Re: Independent Observer's Monthly Report, Time Period: May 1 to May 31,
2014, New Bedford Regional Airport Safety Improvements Project
DEP File No. SE 049-0635

INDEPENDENT OBSERVER REPORT

**PROJECT: Reconstruct, Mark and Groove Runway 5-23, DEP File #SE-049-0635,
NHESP File No. 96-0737**

Photo 7: The lower row of planted shrubs along the West Ditch, south of the RW5 RSA are not visible and based on site conditions are assumed to have drowned. The upper row appeared to be healthy.

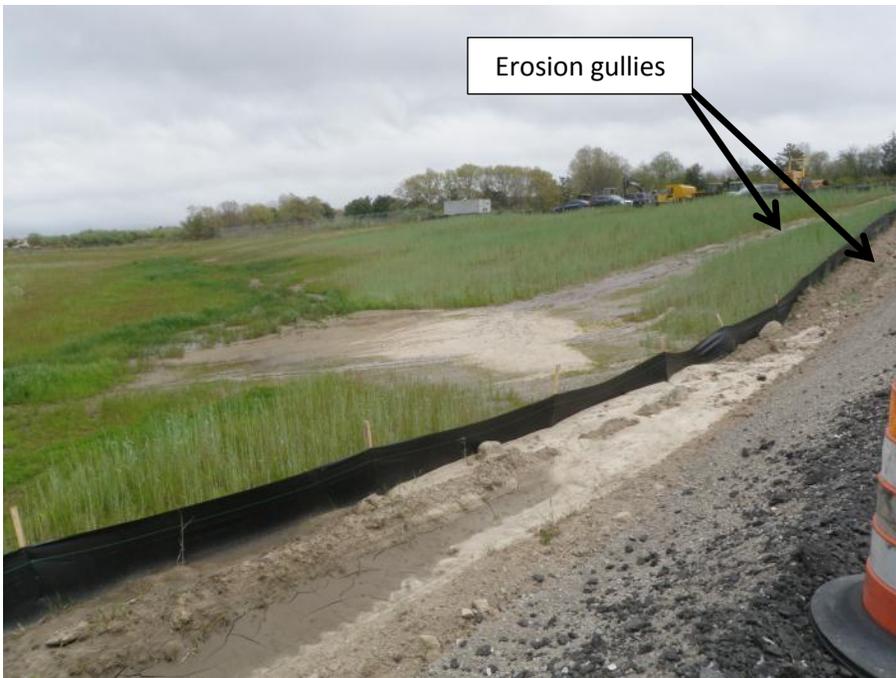
<u>ILS Road</u>		
<ul style="list-style-type: none">• The lower row of planted shrubs along the West Ditch, south of the RW5 RSA are not visible and based on site conditions are assumed to have drowned. The upper row appeared to be healthy (Photo 7).

1. Continue to monitor the E&S barriers throughout the site;
2. Cover any exposed soil surfaces with mulch that are located between the E&S barrier and the West Ditch;
3. Continue to monitoring the replanted shrubs for viability issues; and
4. Monitor pending weather conditions and plan work accordingly.
